# TOGA Central, Henry Deane Plaza, Sydney Landscape RTS Submission

Prepared for TOGA  
December 2022

# Introduction/ Response to submission

This report has been prepared in response to the to the NSW Department of Planning and Environment and the City of Sydney comment the TOGA Central, Henry Deane Plaza, Sydney Development application submission. The Table outlines the comment relating the landscape section and provides response addressing the comments.

# Canopy Coverage

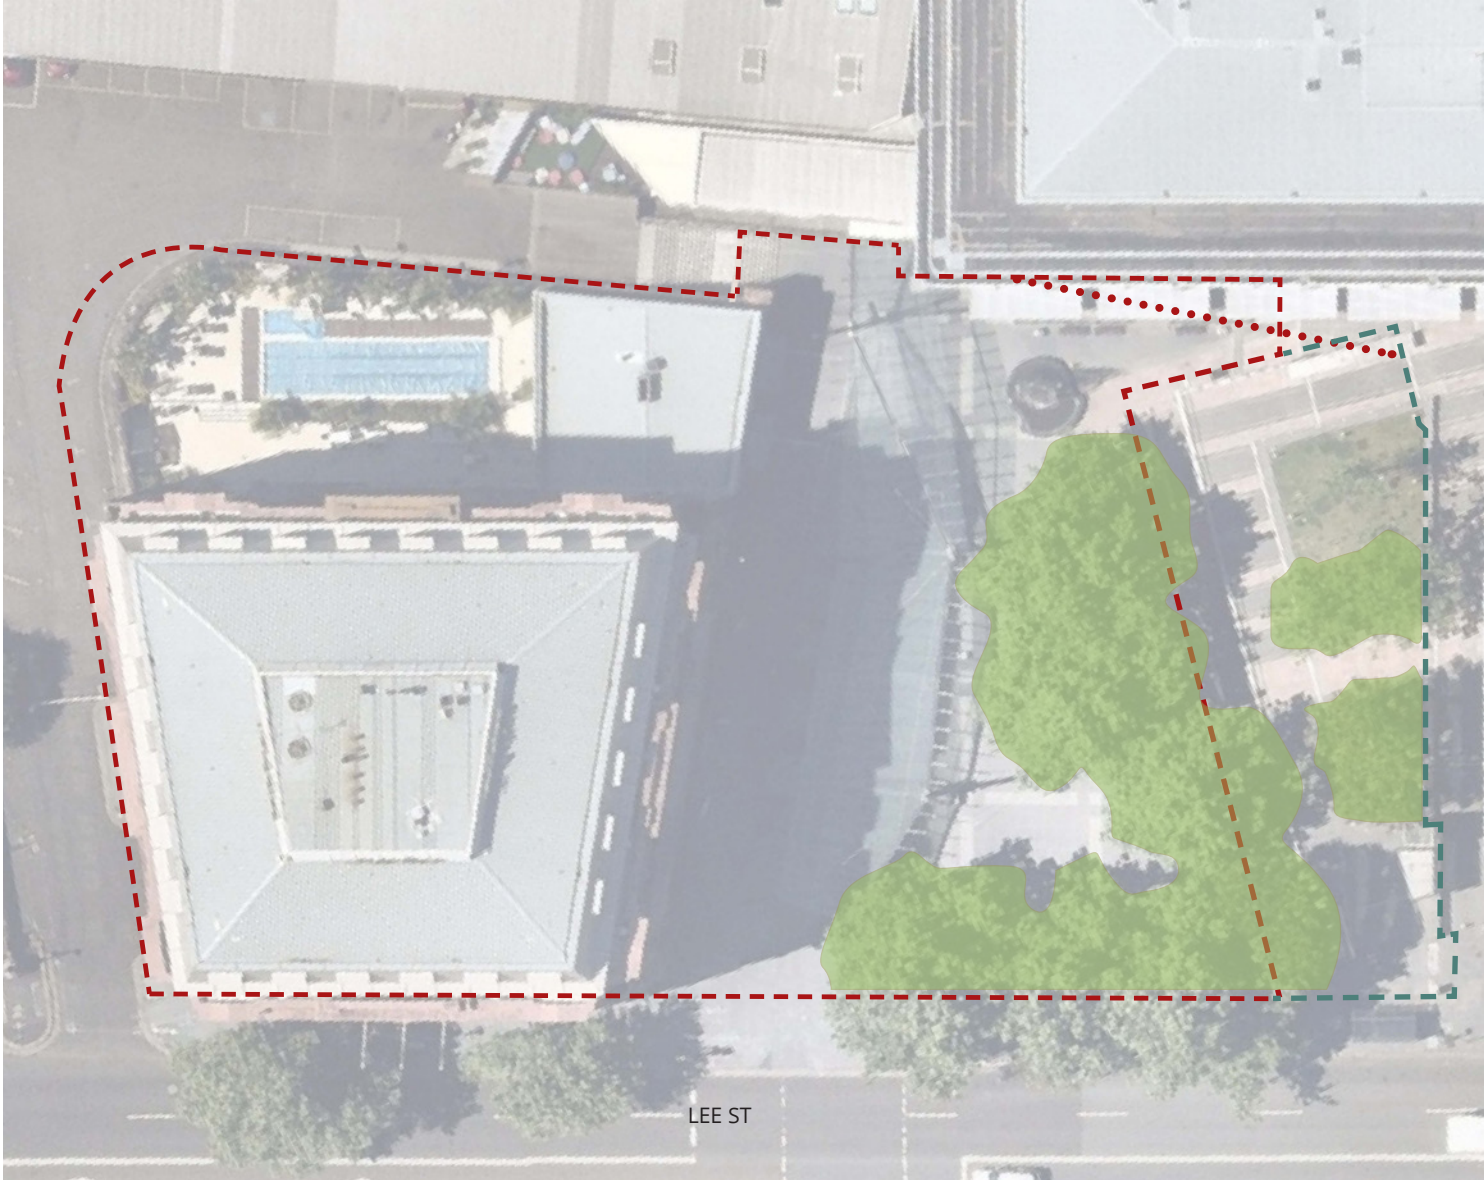
<p>15. Confirm the existing and proposed site tree canopy coverage (in sqm and as a percentage of the site area), including how the proposal aligns with the 15% tree canopy site coverage recommendation of the NSW Government’s draft Greener Places Design Guide 2020.</p> <p>16. To ensure appropriate trees and tree canopy coverage is provided within the site:</p> <p>a) consider replacing the proposed tree species (<i>Livistona australis</i>) with a suitable native alternative of a similar height and that presents a broader tree crown / canopy</p> <p>b) retain the two existing Lee Street street-trees located outside the fPPb.</p> <p>c) investigate options for the planting of additional trees of a suitable species within Henry Deane Plaza.</p>	<p>15. 16.a) - Due to the urban nature of our site and the building footprint, the canopy coverage has been maximised to provide shade and keep with the design intent of Western Gateway Sub Precinct Design strategies.</p> <p>There has been a loss in canopy coverage which is primarily due to the change in site constraints which has impacts the ability to proposed large canopy trees. The existing Henry Deane Plaza is located on deep soil which has allowed the growth or large canopy trees noting that the shade trees within the plaza are not native species. The proposed Henry Deane Plaza design is located on structure which limits the location of large canopy trees due to contrasts including head height constraints to the level below and the structural contains of proposing large trees on structure and comply with with the soil depth required (150m3/per Tree) outlined in the CoS Landscape design codes.</p> <p>Henry Deane Plaza is located on the southern side of the site with the tower overshadowing the plaza for the majority of the day in the middle of summer from 9am-12pm with 58% of Henry Deane Plaza being in shade at 12pm on the summer solstice refer to Page 52 for shadow analysis.</p> <p>The updated RTS Scheme in this report has substituted Cabbage Tree Palms in key locations to enhance canopy coverage where building overshadowing does not currently assist to enhance the shading/canopy coverage of the site.</p> <p>16 b) - The two existing tree on Lee street have been updated to be retained.</p> <p>16 c) Due to the constraints of the site being on structure and the required head heights below providing additional trees and complying the CoS landscape code additional trees within the plaza cannot be achieved.</p>

# Henry Deane Plaza size Comparison

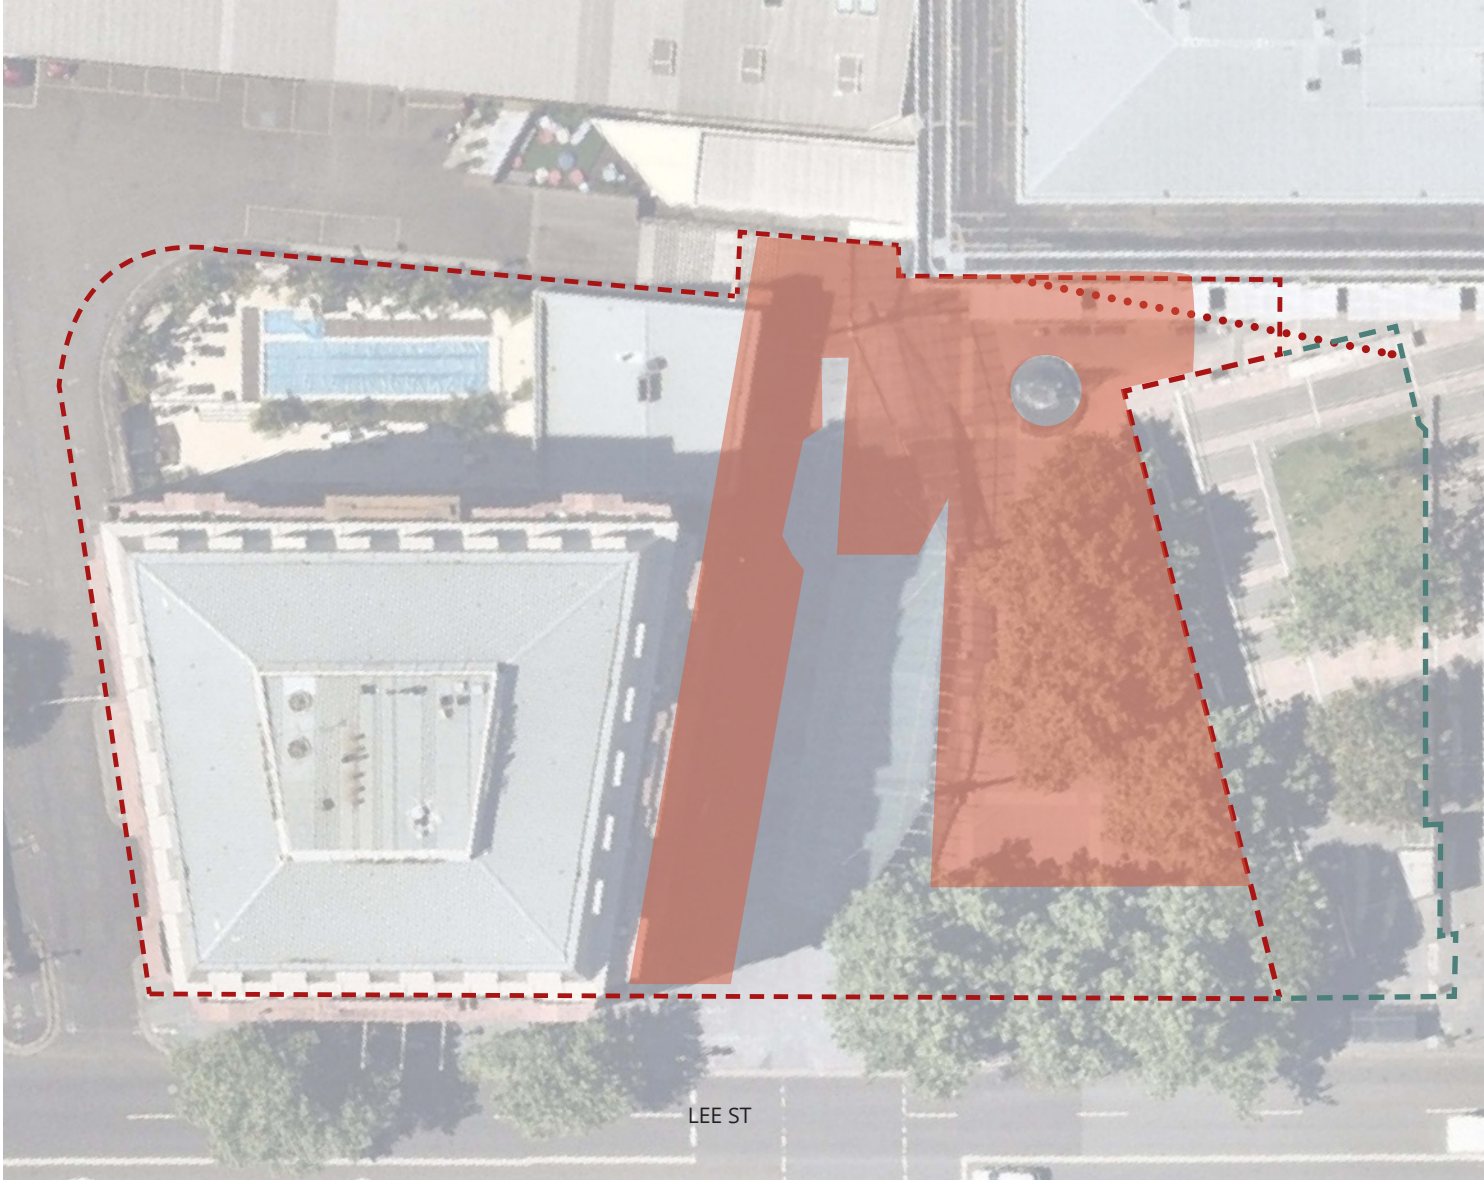
<p>/ 18. Provide a comparison of usable public open space (in sqm and excluding stair, lift, escalator and planter beds) within the existing and proposed Henry Deane Plaza.</p>	<p>The proposed HDP is slightly larger in size (70.9m2) than the exisitng plaza. refer to page 53</p>

## Typical Stair Detail

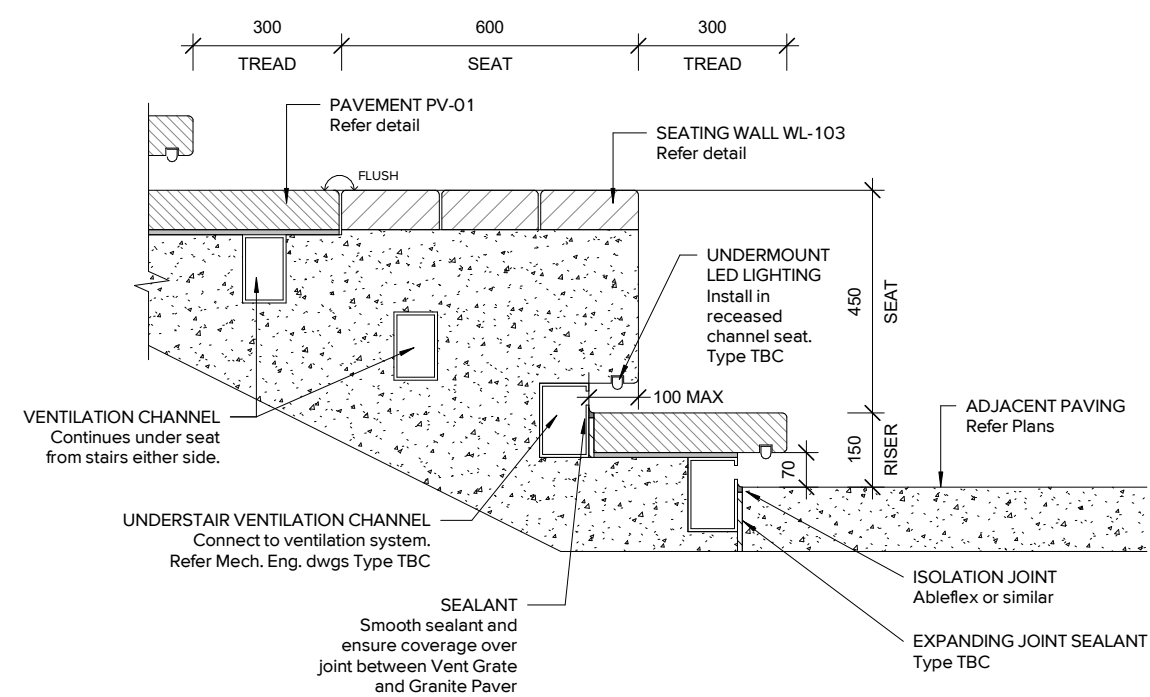
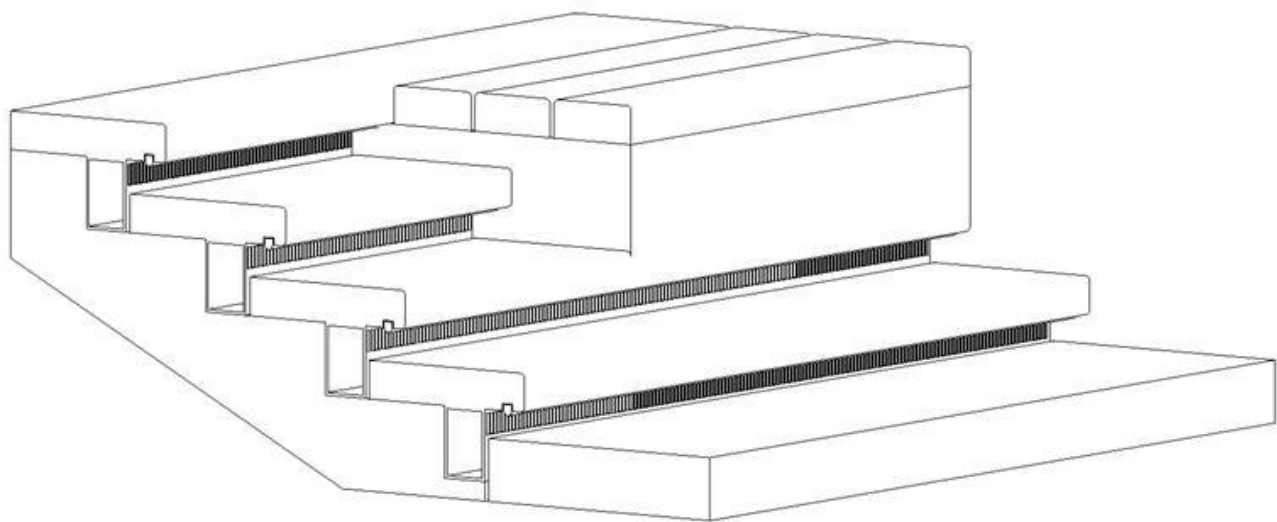
<p>4.2 Landscape drawings</p> <p>The Landscape Drawings do not include sufficient detail and appear to be conceptual only. They do not show adequate detail relating to planting design, surface finishes, levels and grading or lighting. The soil depths and volumes also appear to be insufficient.</p> <p>Recommendations:</p> <ul style="list-style-type: none"><li>• The Landscape Plans must show the full Plaza extent and must include legends, levels, (RL, SSL, TW), grading, surface finishes, lighting, planting design and all other elements to demonstrate a coordinated and complete design.</li><li>• While the Landscape and Public Domain Report includes details of the proposed landscaping and describes aspects of the Plaza design, this information needs to be captured in the Landscape Plans. A comprehensive landscape drawing set for the whole development proposal is needed to confirm that the landscape design is feasible, buildable, that plaza levels work, and to allow the City to provide relevant landscape conditions.</li><li>• All planting in steps and planters set down in the plaza slab are to be designed with soil depth and soil volume to support the healthy growth of trees and comply with the Landscape Code.</li><li>• A full review of the upper ground level grading must be undertaken to ensure equitable access is provided for all users to pavements and plaza that comply with AS1428 and the City's Inclusive and Accessible Public Domain Policy and Guidelines.</li><li>• Resolution of the levels in the publicly accessible plaza and provision of an equitable and dignified access from the street to the precinct and towers is required.</li><li>• Details of the design of the Devonshire Street tunnel entry are required.</li></ul>	<p>An updated drawings set has been provided to address these comments, including urban element planting and trees locations and schedules. please refer to drawings number 000-701</p> <p>Details have been provided on page 53-54</p> <p>All plant soil depths will conform to the CoS landscape code.</p>
